BAKERSFIELD (ITY SCHOOL DISTRICT (IO) 24X40 TEMPORARY PORTABLE (LASSROOMS AT ROOSEVELT ELEMENTARY SCHOOL BAKERSFIELD, KERN (OUNTY, (ALIFORNIA)

BID OPENING: May 9th, 2024 at 11:00am Job No. 1317.1 Appl. No. 15-6 File No. 03-123198

ADDENDUM NO. #01

PARTIAL DEMO SITE PLAN_SCALE : 1" = 20'-0"

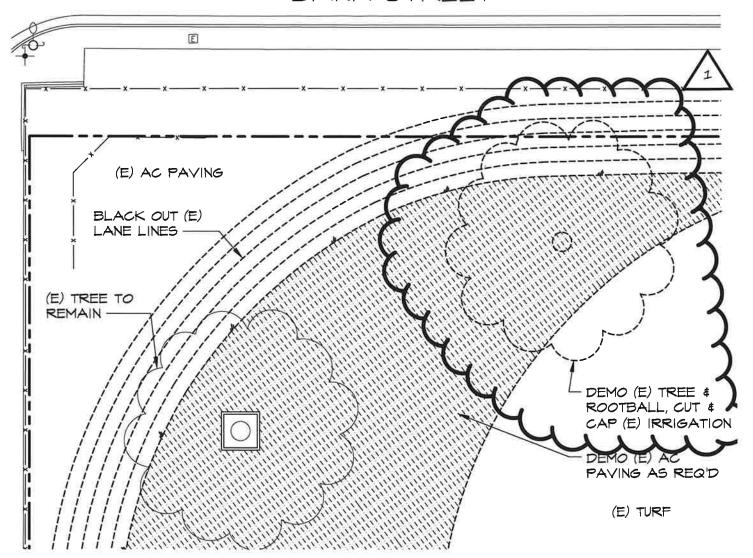
- 1-1) Refer to DSA Approved Drawings, Sheet No. C2 GRADING PLAN NORTH PORTABLES AND A2 PARTIAL SITE PLAN AND PARTIAL DEMO SITE PLAN "B" PARTIAL DEMO PLAN;

- a. ADD: Demolition of existing tree and rootball shown in track and infill and compact as required for AC Paving shown on Plans. See attached Drawing No. 01.

ADD TREE DEMOLTION ITEM • 1-1a

PARTIAL SITE PLAN.

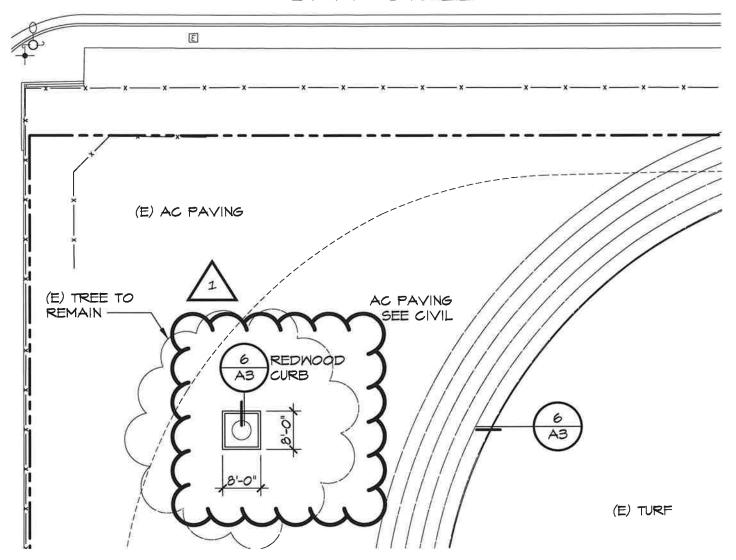
- 1-2) Refer to DSA Approved Drawings, Sheet No. A2 PARTIAL SITE PLAN AND PARTIAL DEMO SITE PLAN "A" PARTIAL SITE PLAN;
 - a. ADD: Redwood header to existing tree scheduled to remain in asphalt as indicated per attached Drawing No. 2.

ELECTRICAL SITE PLAN

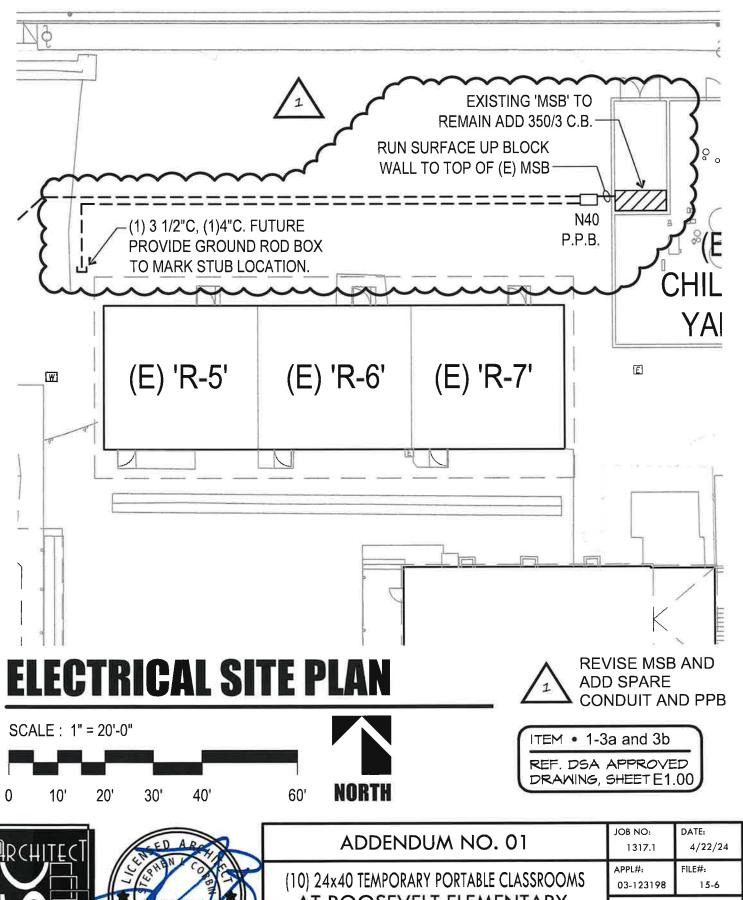
- 1-3) Refer to DSA Approved Drawings, Sheet No. E1.00 ELECTRICAL SITE PLAN, SYMBOL LEGEND AND NOTES;
 - a. REVISE: MSB to be "EXISTING MSB TO REMAIN ADD 350/3C.B." in lieu of "REPLACE EXISTING MSB" as indicated per attached Drawing No. 03.

- b. ADD: N40 PPB, conduit & F08 ground rod box as indicated per attached Drawing No. 03.
 - c. ADD: Flex conduit for power between Buildings as indicated per attached Drawing No. 04.

ITEM • 1-3c and 3d

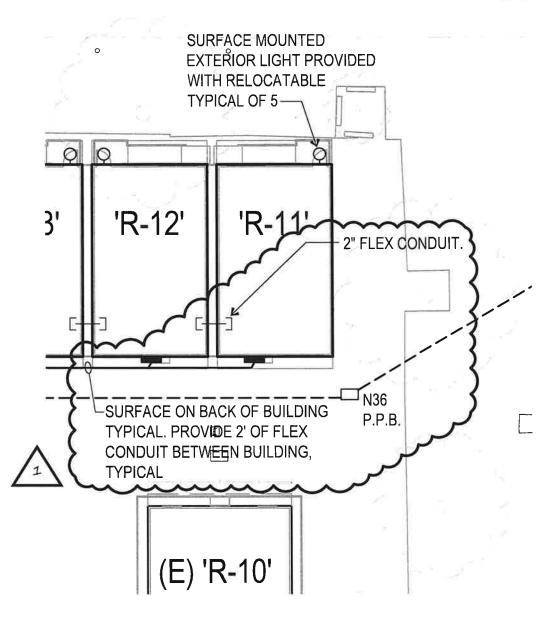
- d. DELETE: Words "MINIMUM 2'-8" BETWEEN FACES OF TWO RELOCATABLES TYPICAL" for flex conduit shown to right of Building R-11 as indicated per attached Drawing No. 04.

ITEM • 1-3e, 3f, 3g

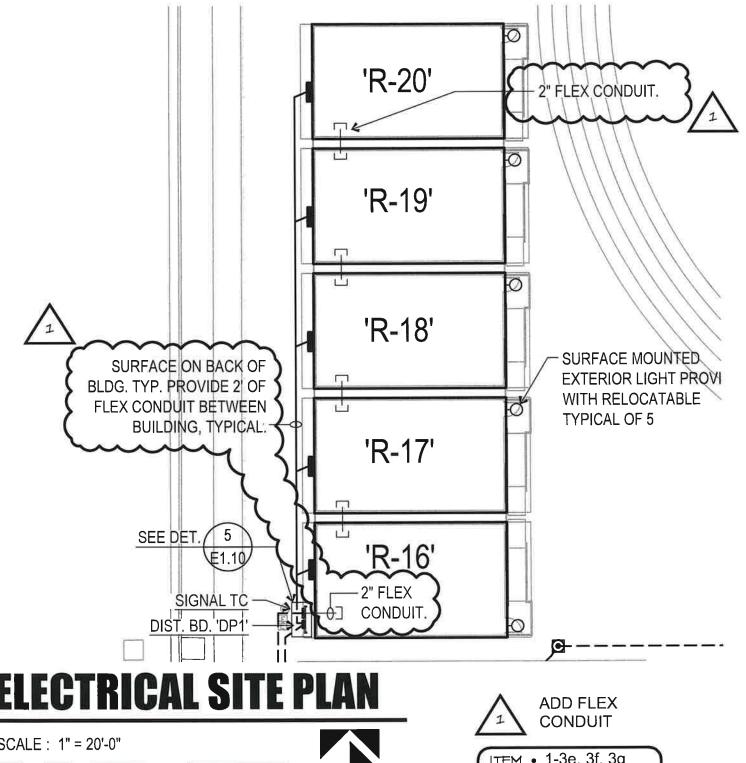
- e. DELETE: Words "MINIMUM 2'-8" BETWEEN FACES OF TWO RELOCATABLES TYPICAL" for flex conduit shown to right of Building R-20 as indicated per attached Drawing No. 05.

- f. ADD: Flex conduit for signal conduit at Building R-16 as indicated per attached Drawing No. 05.
 - g. REVISE: Note "SURFACE ON BACK OF BLDG TYP" shown to the left of Building R-17 as indicated per attached Drawing No. 05.
